SUBJECT: REDISTRIBUTION OF TECHNICAL SPECIFICATION PAGES FOR AMENDMENT  
NOS. 180 AND 181 - BROWNS FERRY NUCLEAR PLANT, UNIT 2 (TAC NOS.76902  
AND 76934)

ATTACHMENT TO LICENSE AMENDMENT NO. 180

FACILITY OPERATING LICENSE NO. DPR-52

ATTACHMENT TO LICENSE AMENDMENT NO. 181

APRM Flow Reference Scram and APRM Rod Block Settings  
 Fig. 2.1-1

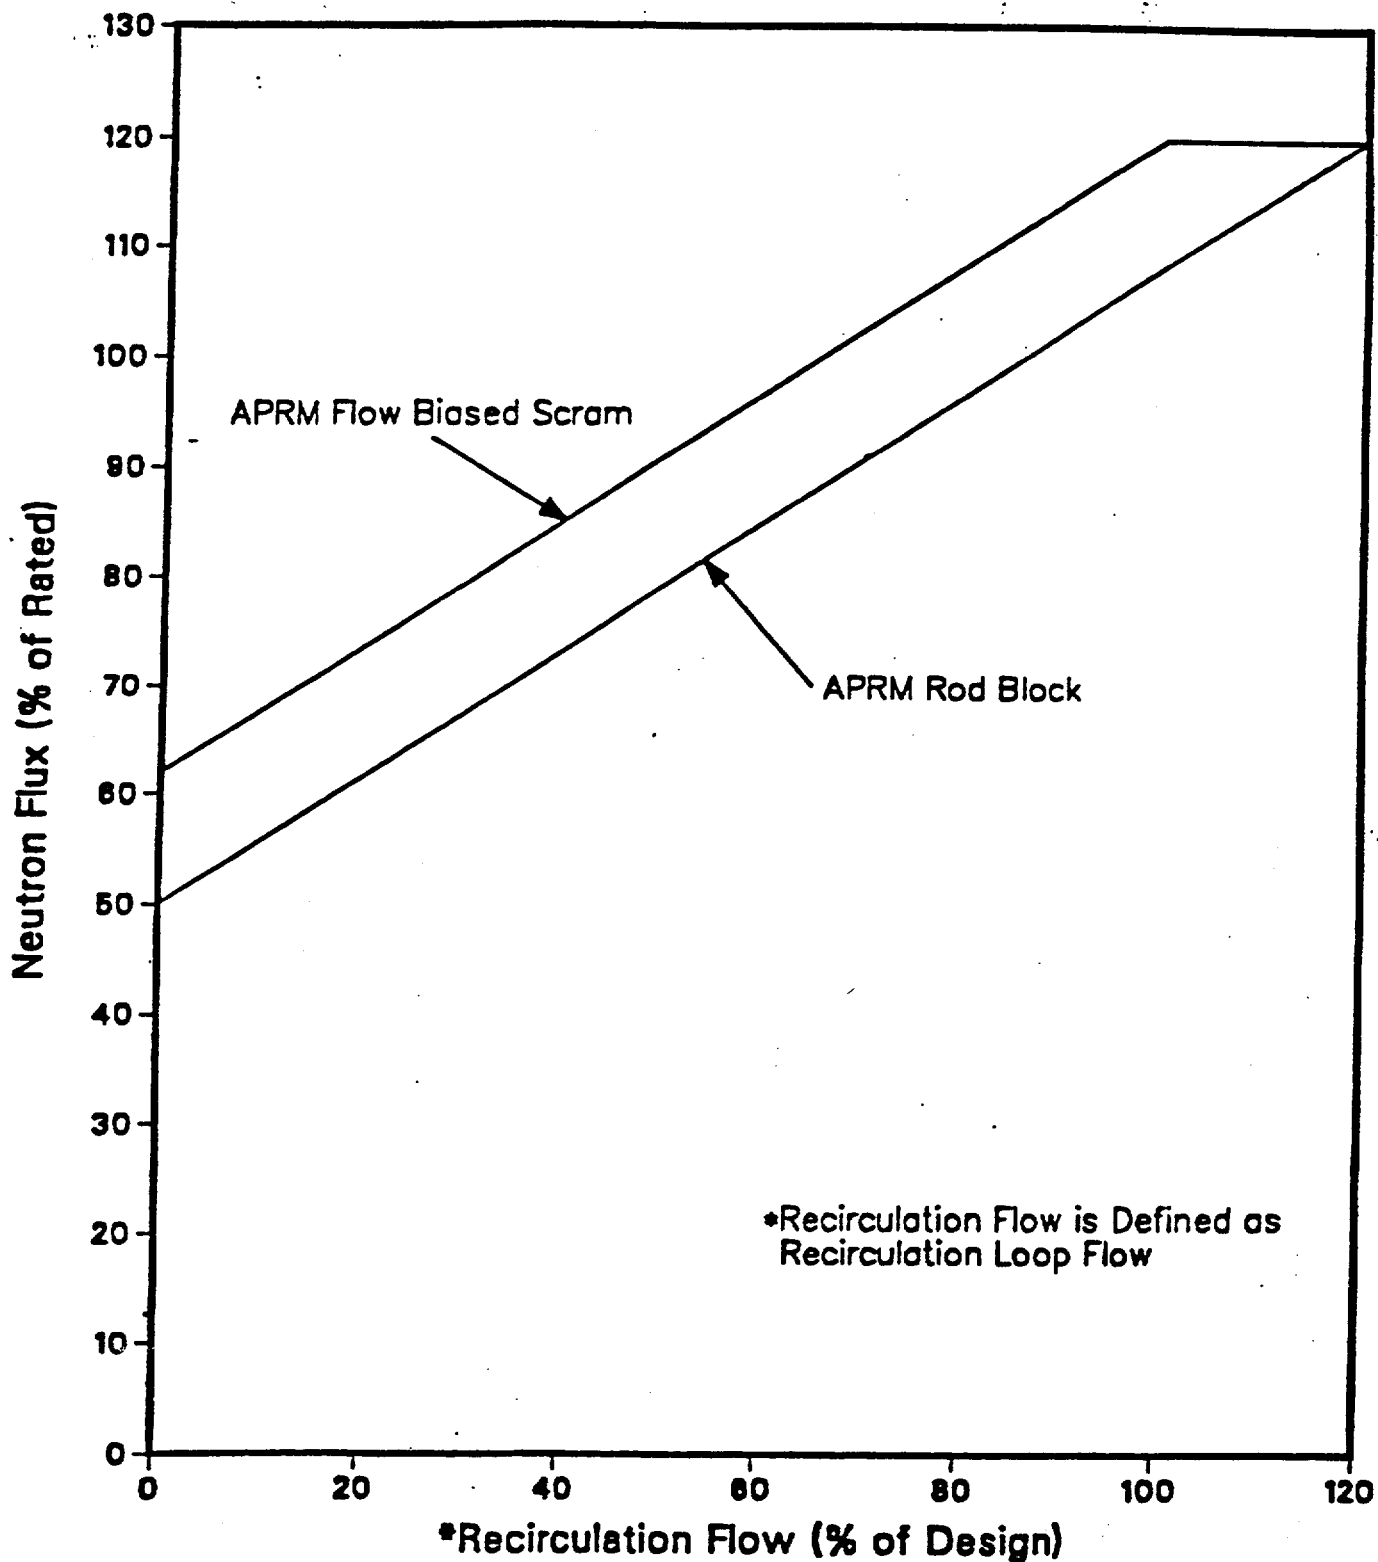
- c. The APRM Rod Block trip setting shall be:

$$SRB \leq (0.58W + 50X)$$

where:

SRB = Rod Block setting in percent of rated thermal power (3293 MWt)

W = Loop recirculation flow rate in percent of rated (rated loop recirculation flow rate equals  $34.2 \times 10^6$  lb/hr)
